POL PIER REPAIRS  
LAJES FIELD, AZORES

CONSTRUCTION INSPECTION VISIT NO. 2  
JULY 1980

CONTRACT NO. N-62477-79-C-0021  
MODIFICATION P-00001

DEPARTMENT OF THE NAVY  
NAVAL FACILITIES ENGINEERING COMMAND  
CHESAPEAKE DIVISION  
WASHINGTON, D. C.

DOLPHIN NO. 3 - ROCK ANCHORAGE  
Concrete Cap Opening Made by Drilling a Series of  
Rotary Bit Holes.

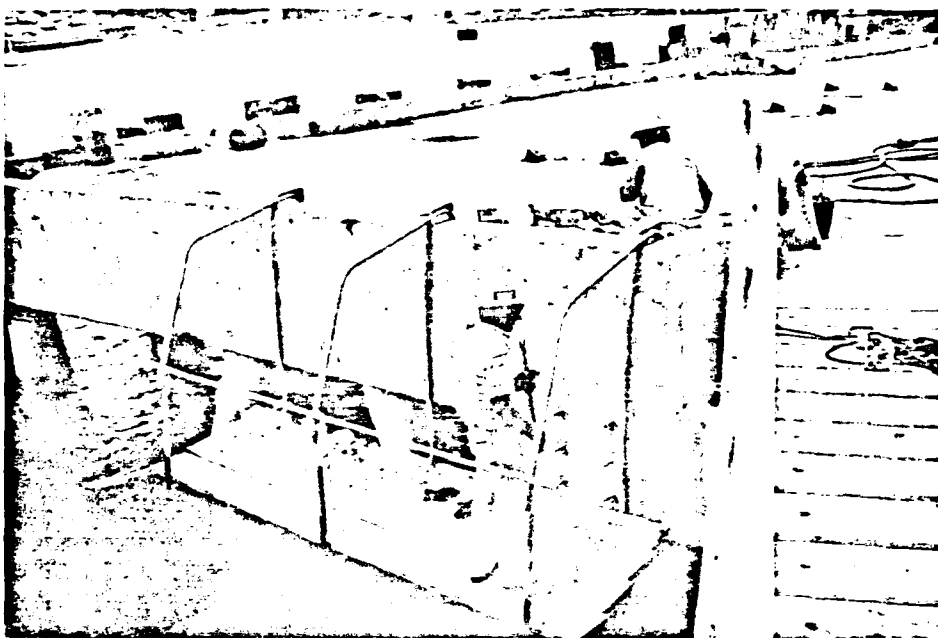
With respect to use of the rotary bit to drill the opening in the concrete cap, this results in smooth sides which will later have to be roughened and belled out for proper bond and shear development. Also, additional side chipping is needed to expose sufficient reinforcement for butt weld splicing. This was told to the job personnel.

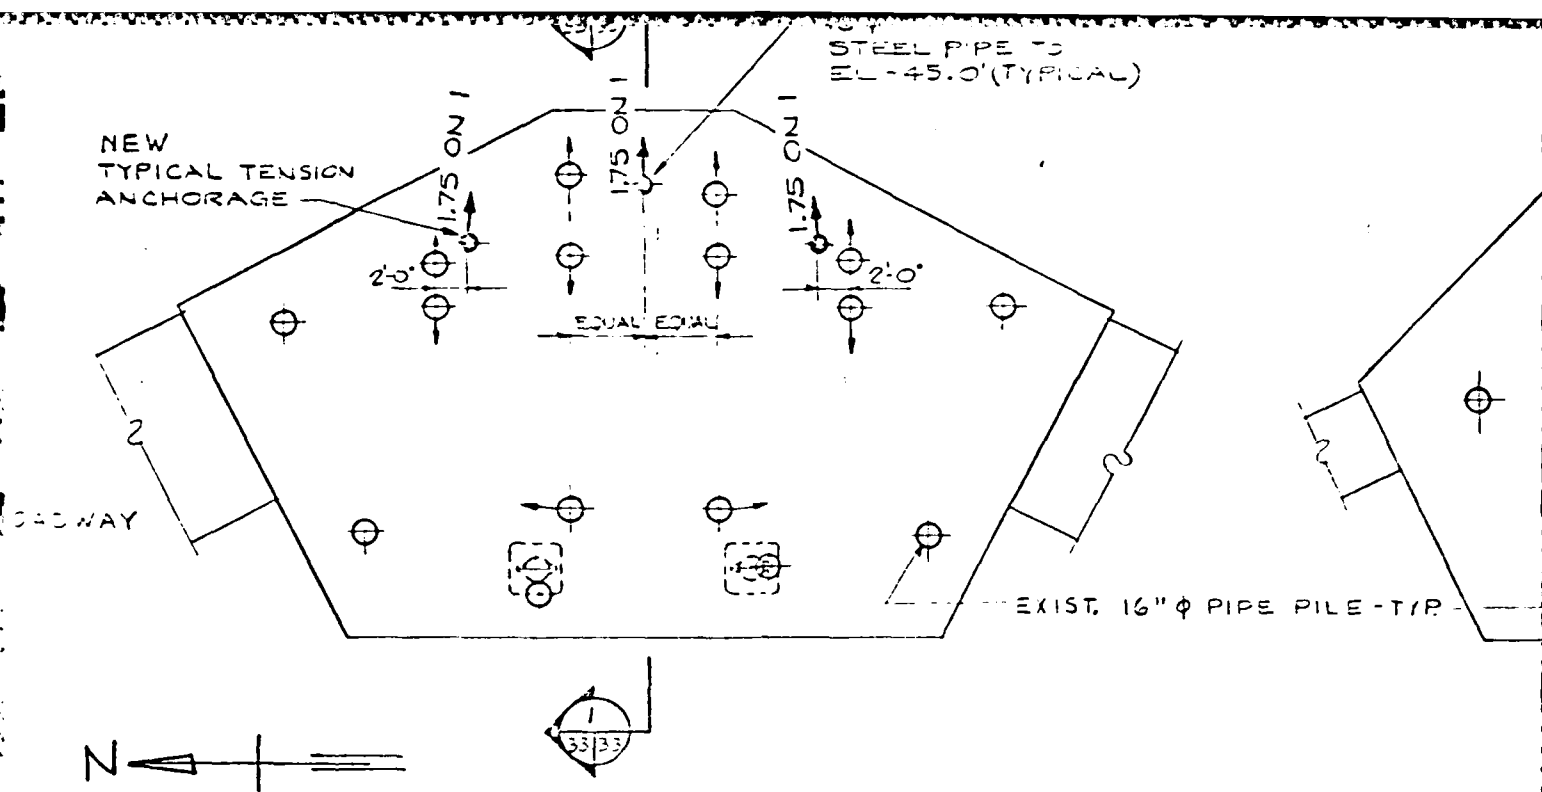
The Contractor stated that he had found the harbor bottom about 6 to 8 feet higher than shown on the Contract drawing, namely, Sheet No. 3 NAVFAC Drawing 3017682. The Contractor attributed this change to the fact that there had been considerable siltation in the area, and a great deal of sand had been accumulating on the beaches in recent months.

top of the Pier, sounding at the same points as the Contract plan soundings — made in January 1979. Assuming that the deck level (not the curb) is at Elevation +11.0 ft., referring to the Mean Low Water datum, it was found that the harbor bottom has come up about 3 feet during the interval from January 1979 to July 1980. Attached is a sketch showing water depth changes.
